Integrated Plant Safety Assessment Systematic Evaluation Program

Millstone Nuclear Power Station, Unit 1

Docket No. 50-245

Draft Report

Figure VI-7.C.1.-2b. 480 Volt Distribution 12C-12D Bus After

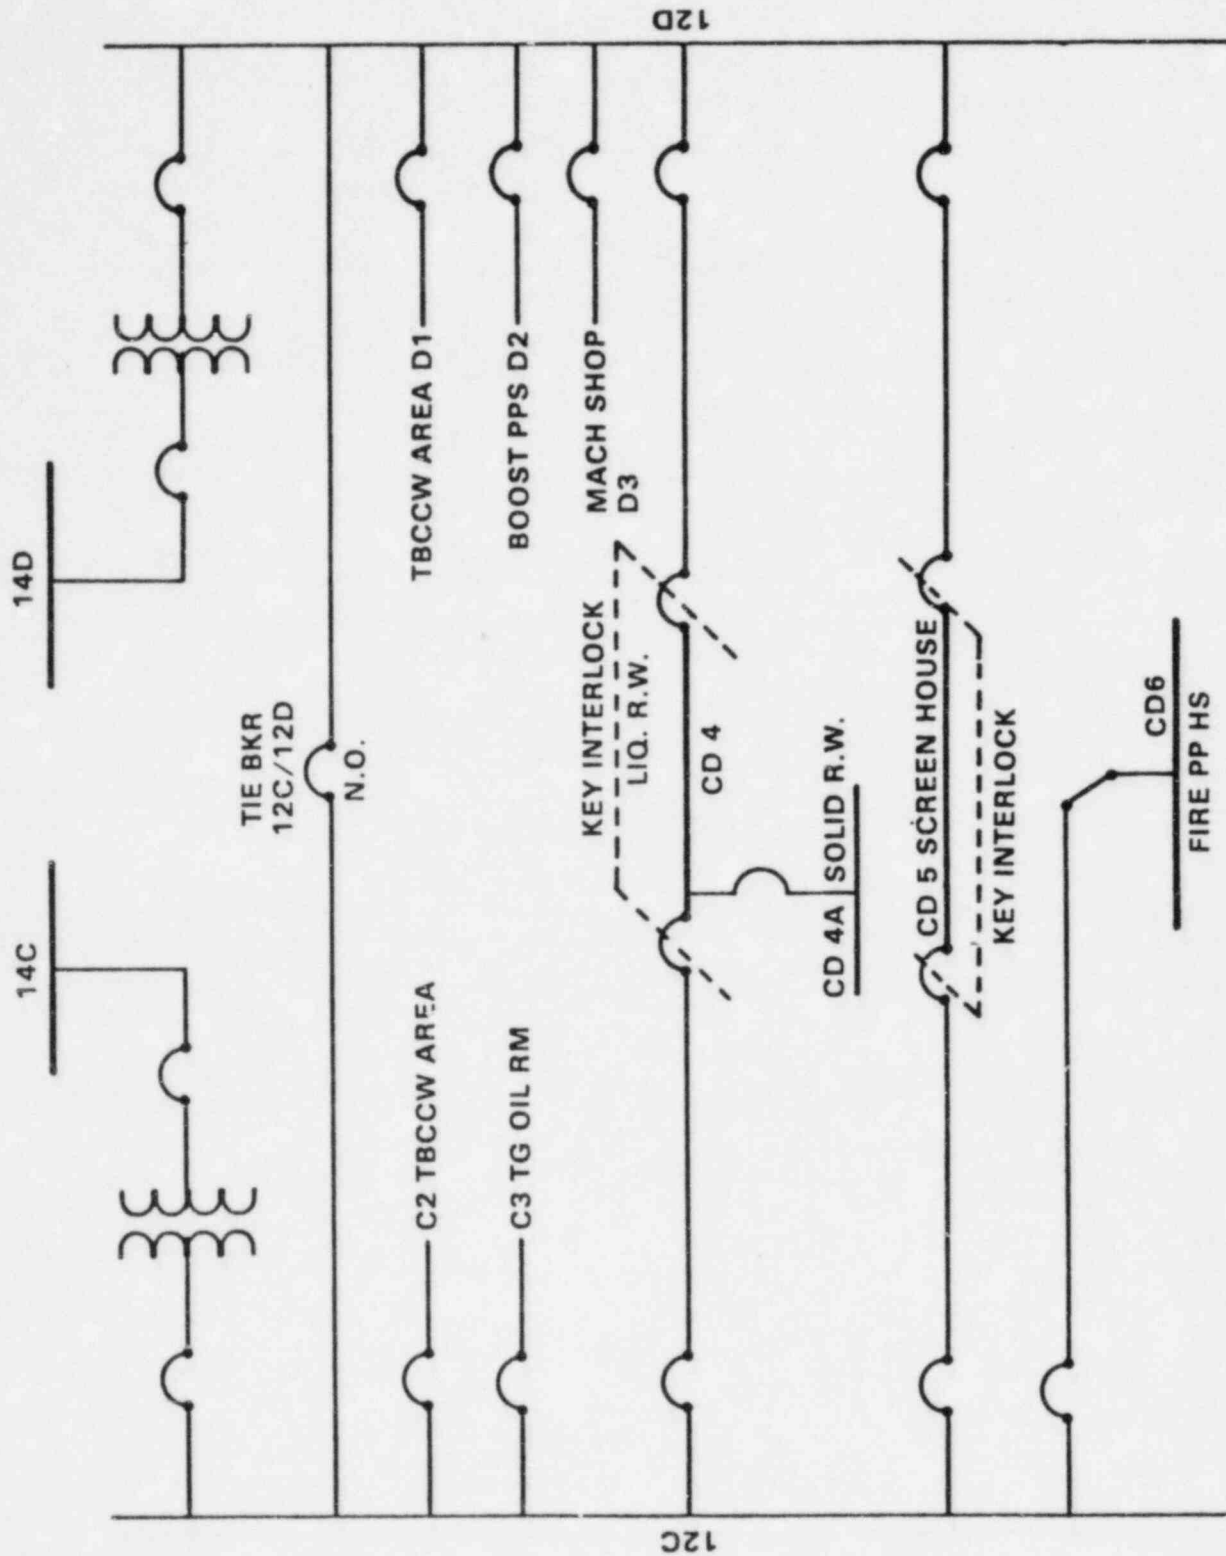
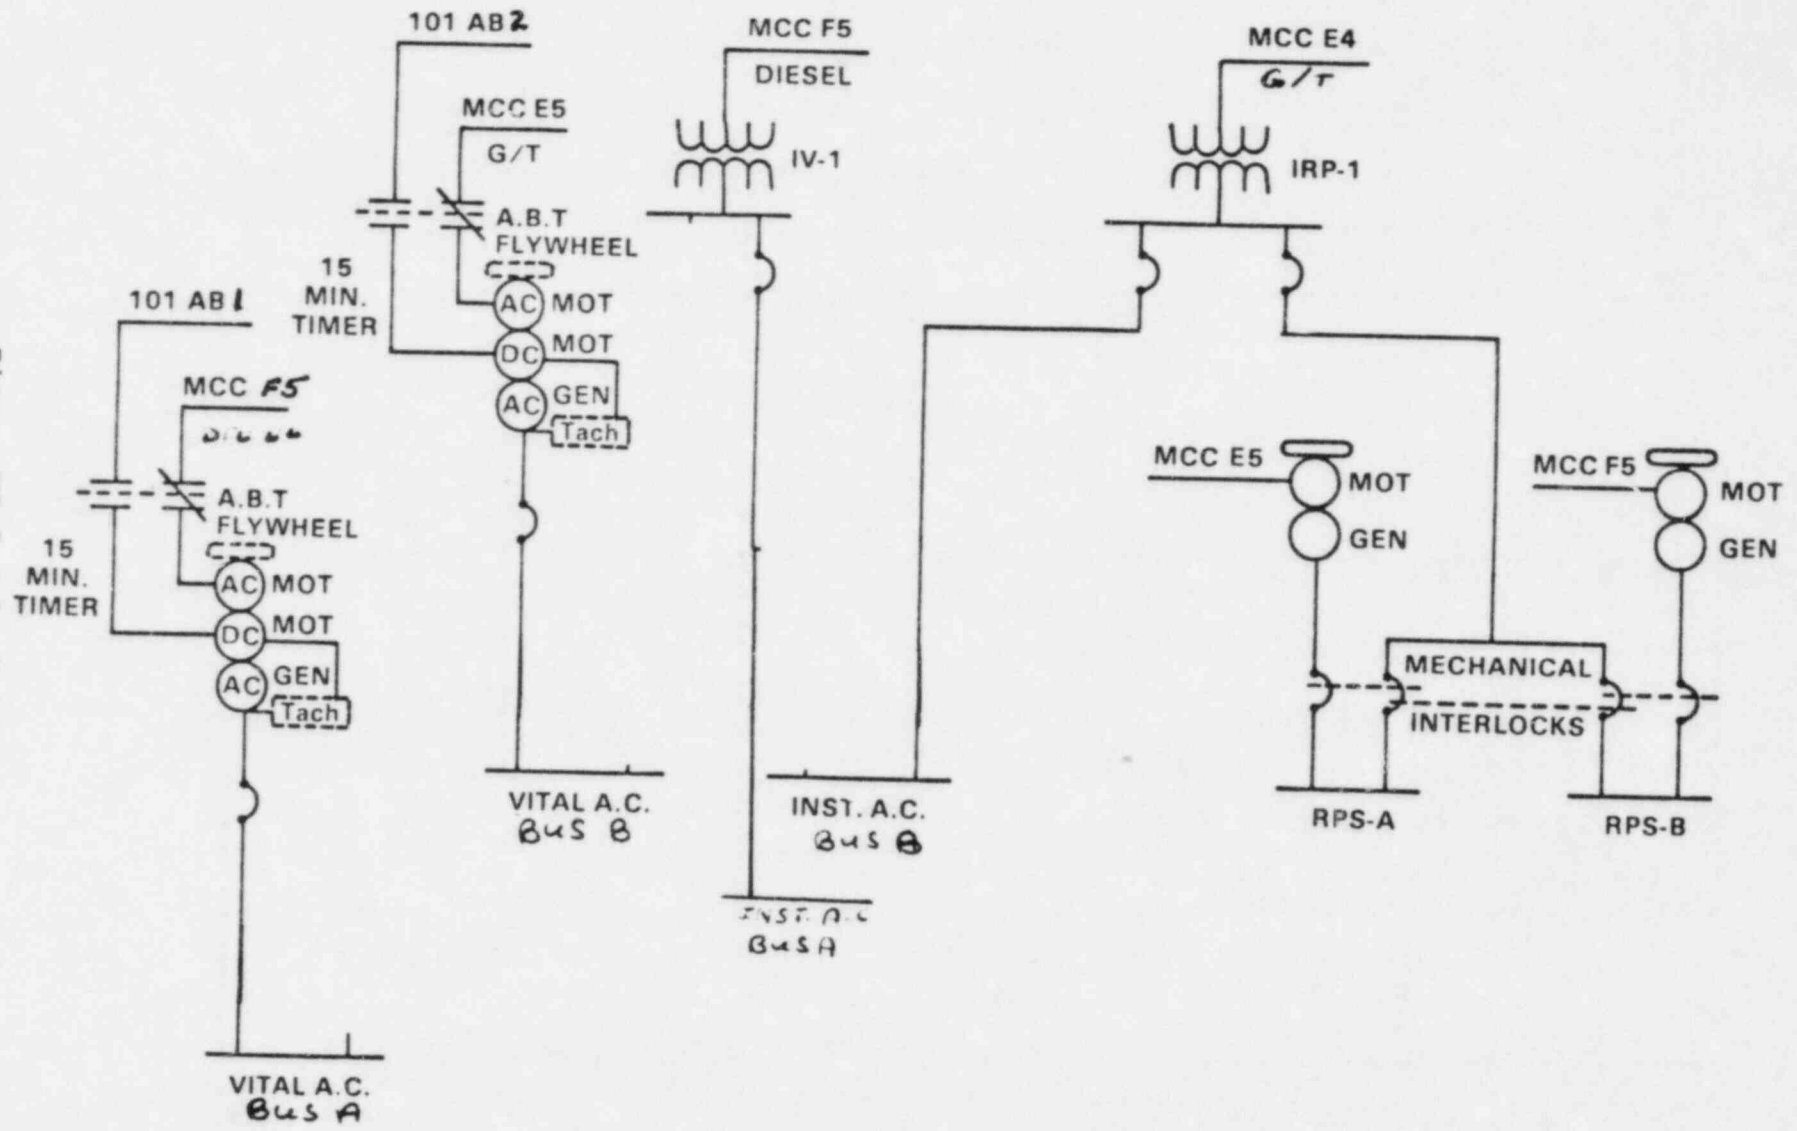
The present design of the ac and dc systems is shown in Figures VI-7.C.1-1a through VI-7.C.1-1d. They show automatic bus transfer devices on ac motor control centers EF3, FE3, EF7 and CD6 and on the Instrument ac (IAC) and Vital ac (VAC) buses, as well as manual transfers on dc motor control centers 101AB-1, 101AB-2, and 101AB-3. The ABT on the Vital ac bus does not actually transfer loads between redundant power sources since the M/G set acts as an isolation device. However, it was felt necessary to include this in the redesign for other reasons related to the need to redesign the Instrument ac (see issue VII-3). The changes for ac MCCs EF3, FE3, EF7 and CD6 simply involved removing the ABTs and hard wiring the buses directly to a power source. This is shown on Figures VI-7.C.1-2a and VI-7.C.1-2b. Similarly, for the dc MCCs AB-1, AB-2,

and AB-3, the manual bus transfers were removed as shown in Figure VI-7.C.1-2d. The redesign for the IAC and VAC buses were more complicated. This is because these buses do not supply redundant load groups. That is, they each supply needed service to the whole plant (this aspect is treated in issue VII-3). Thus, in order to remove the ABTs and therefore connect the bus to a particular power source, it becomes necessary to split the loads on these buses in half according to the associated equipment train which they affect. This resulted in a redesign which created separate IAC and VAC buses for each train. This is shown on Figure VI-7.C.1-2c. A further complication was that in the case of the control logic for the shutdown cooling system, only one logic train existed, as shown in Figure VI-7.C.1-3. This required the creation of a new control logic design which had two trains, one to be associated with each new IAC bus. This is shown on Figure VI-7.C.1-4 sheets 1 + 2. All these modifications were evaluated by changing the fault trees from the Millstone-1 Interim Reliability Evaluation Program (IREP) Study to represent the modified electrical power systems design discussed above, and then requantifying the dominant event tree sequences to determine if any risk reduction was realized.

Figure VII-3-1. Vital AC-Instrument AC Reactor Protection Buses Before

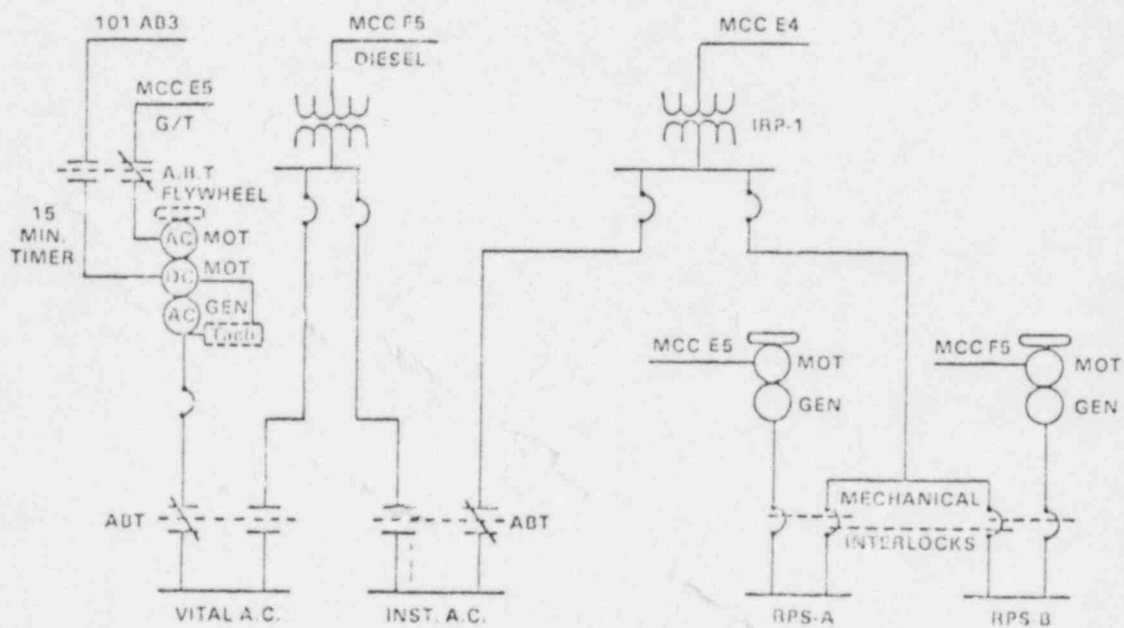
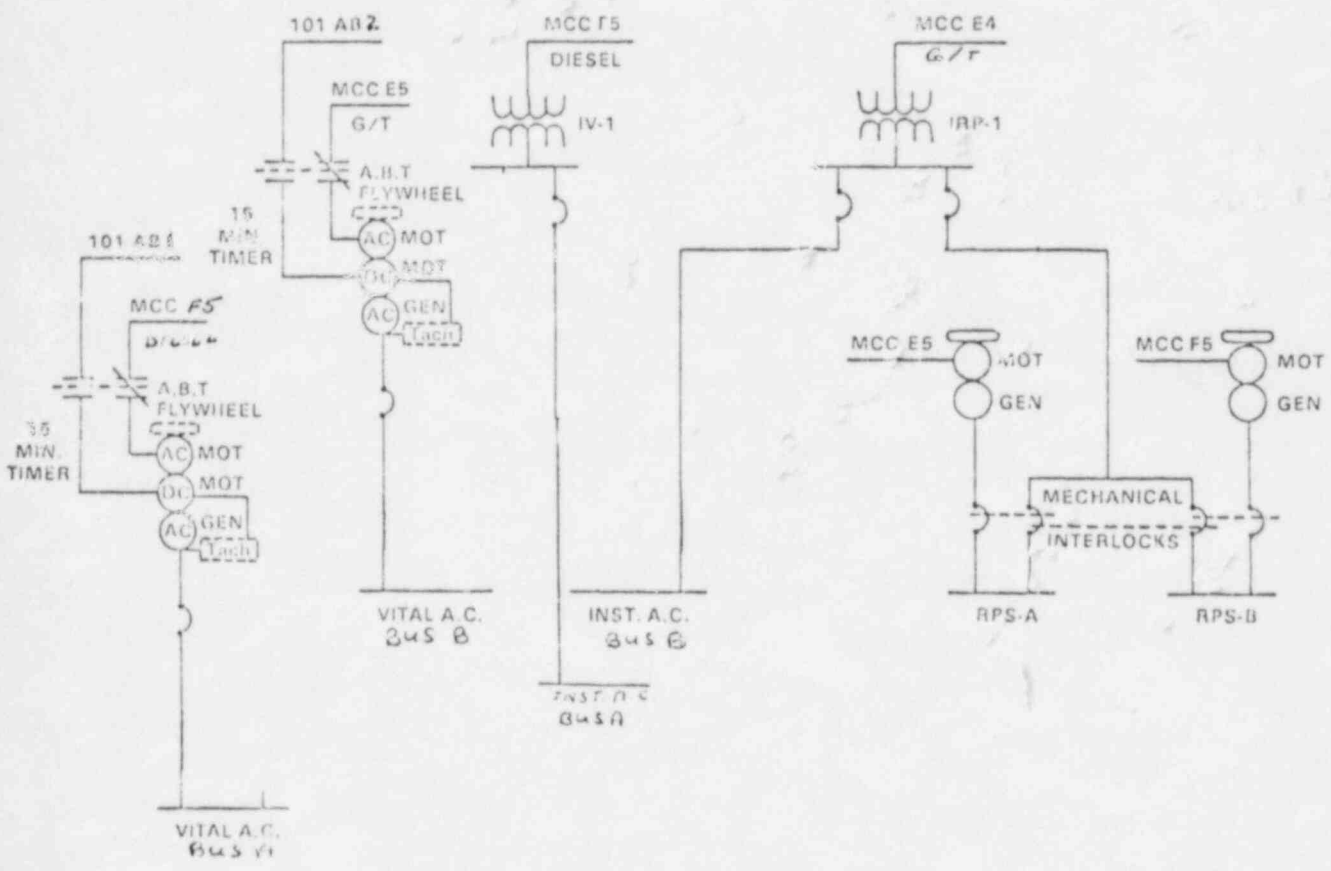
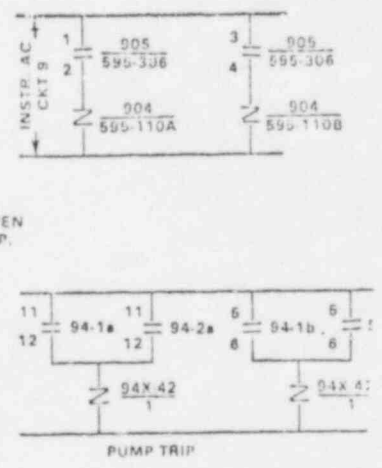
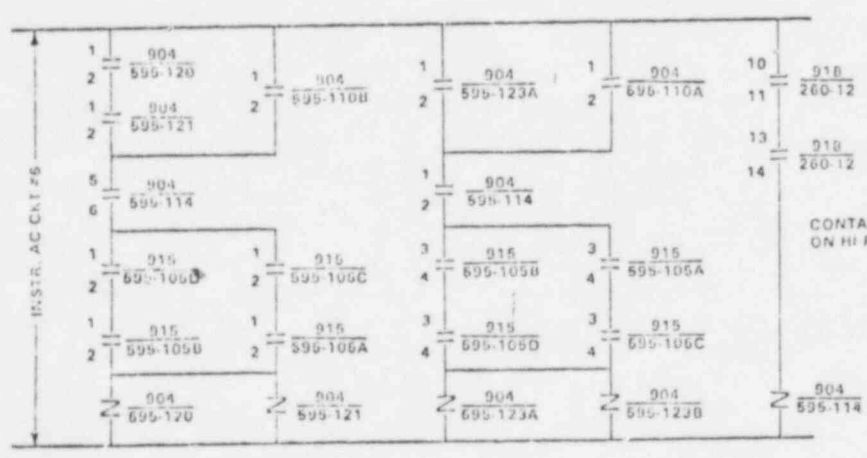
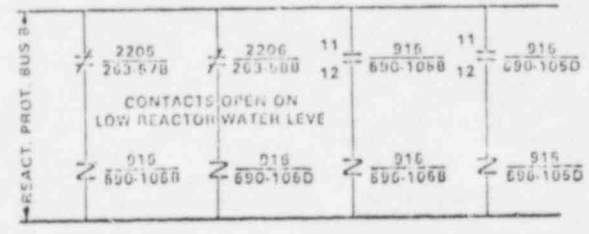
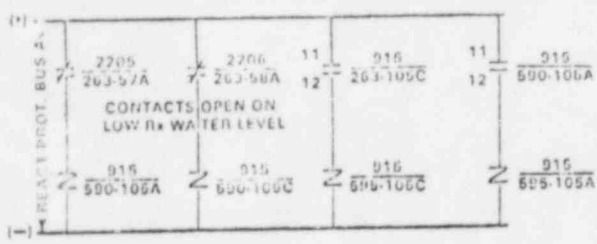
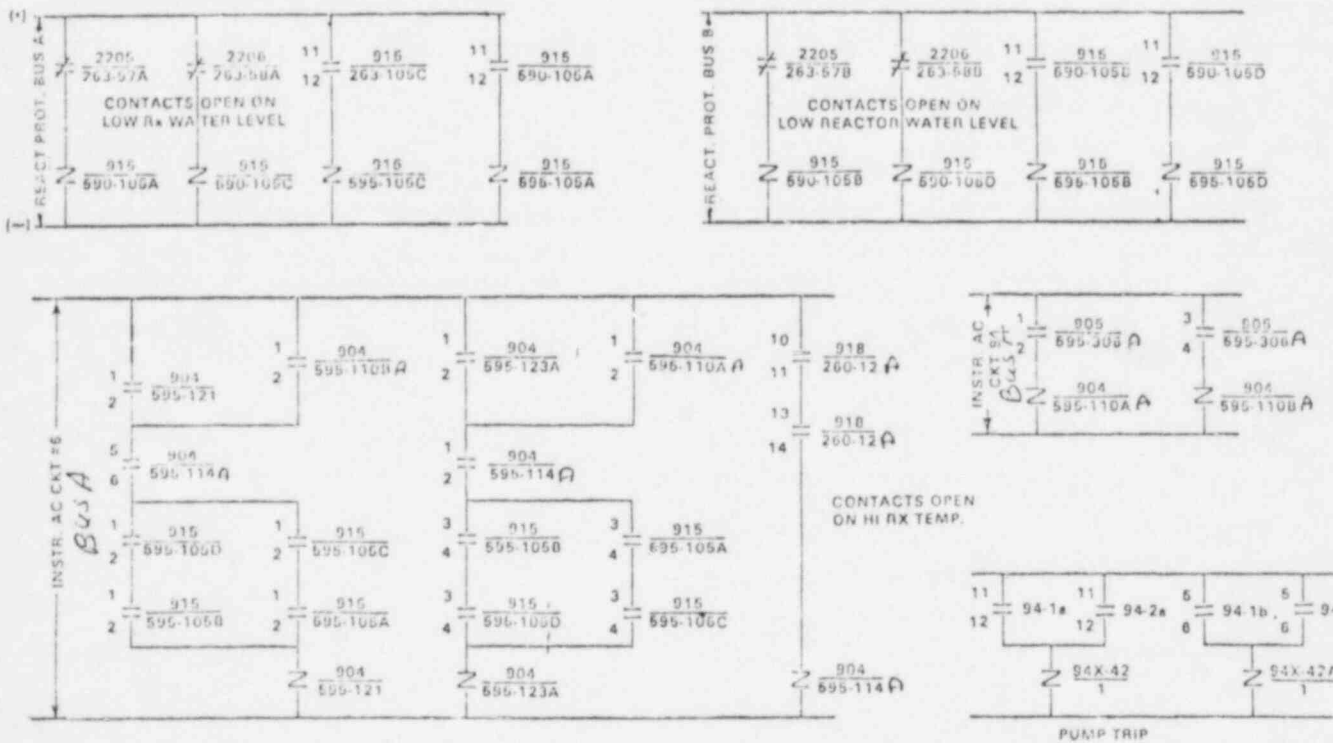
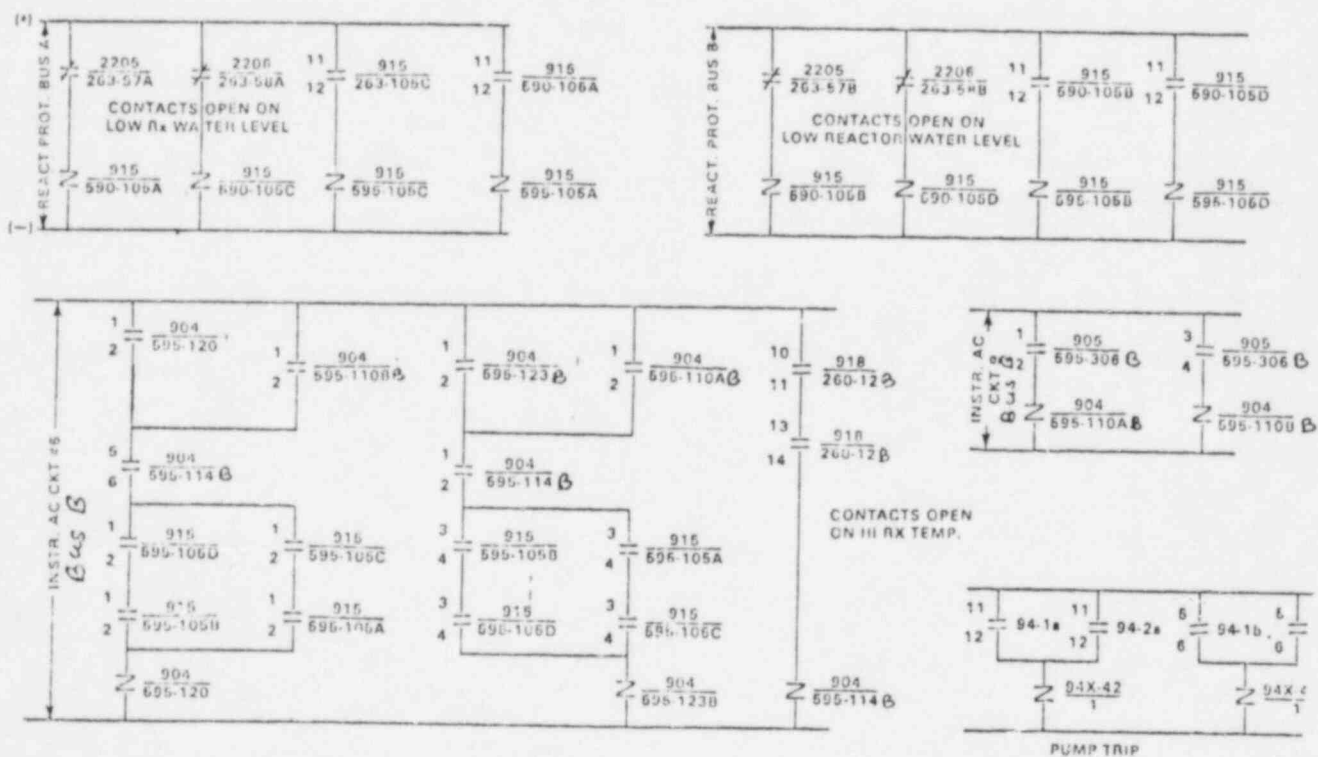
The present design of the instrument ac power source is shown in Figure VII-3-1, along with the initial ac and RPS sources. Although the single vital ac bus was not mentioned in the evaluation, it is also nonredundant. Additionally, because of the way it is intertied with the shared backup power for itself and the IAC bus, it was felt that no logical redesign of IAC to provide redundant supplies could be accomplished without also including VAC in the redesign. The redesign which was developed is shown in Figure VII-3-2. Since both the IAC and VAC buses supply power to the entire plant, and do not represent redundant load groups, it became necessary to split the loads in half according to the associated equipment train which they affect. For most cases, the

separation of A train and B train loads was rather simple. There was, however, one complication because only one control logic train existed for the shutdown cooling system, as shown in Figure VII-3-3. This required the creation of a new control logic design which had two trains, one to be associated with each new IAC bus. This is shown in Figure VII-3-4, sheets 1 and 2. All these modifications were evaluated by changing the fault trees from the Millstone-1 Interim Reliability Evaluation Program (IREP) study to represent the modified IAC/VAC system design discussed above, and then requantifying the dominant event tree sequences to determine if any risk reduction was realized.
